30th November 2007

Consultation GB ECM-09 - For the charging and access arrangements associated with SQSS design variations.

Figure 1: £/kW discounts for increasing line km in different zones.

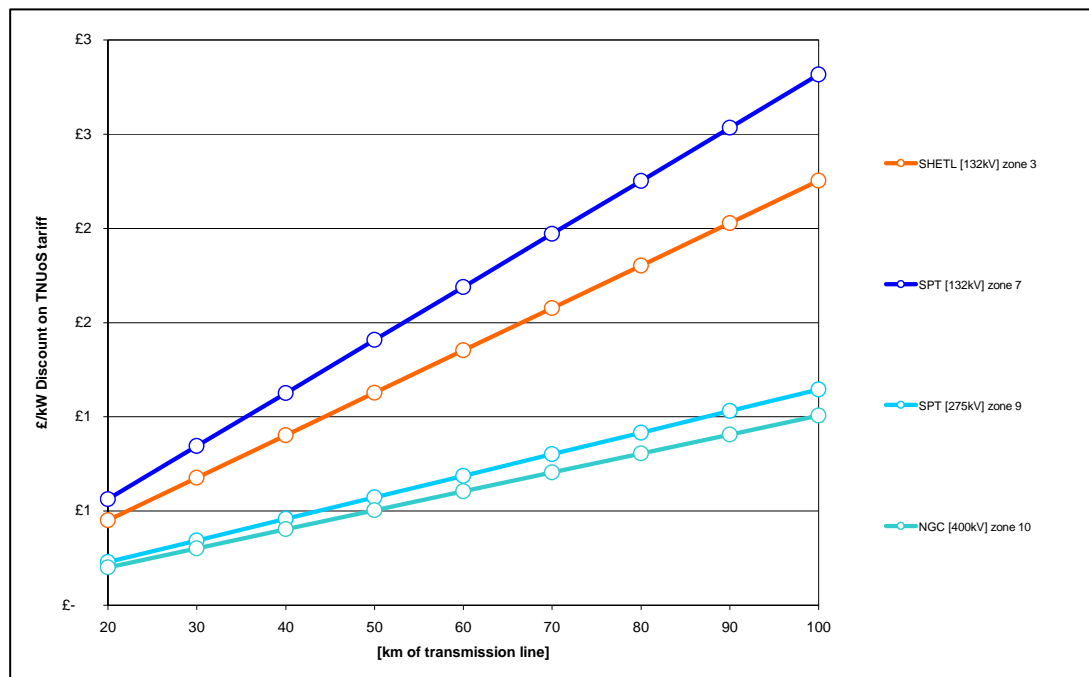
Figure 1 presents £/kW discounts for 132kV, 275kV and 400kV connections in different zones, at a line length of 20km to 100km.

It seems sensible that the TNUoS discount encourages stations further away from the system to opt for a single line and the higher the cost of the circuit, such as 132kV line, the greater the discount.

If we consider an onshore 100MW wind farm, connected in zone 3 (SHETL), the range of discount increases linearly from depending on the length of single circuit. This pattern is similar in all SHETL managed zones, where the station is connected on a 132kV line.

The circuit discount would equate to 1 to 2 days of lost revenue for the generator, assuming a 30% load factor and circuit length of 20-50km. This is lower than the earlier ECM06 consultation which included the substation discount. ECM06 would have provided the approximately 3-7* days of lost transmission access per annum for a ROC accredited wind farm. Under those proposals if a project qualified for a £3.12/kW substation discount then the generator is provided with 6-12* days of compensation. We believe 1-2 days compensation appears far more reasonable for the risk of circuit unavailability.
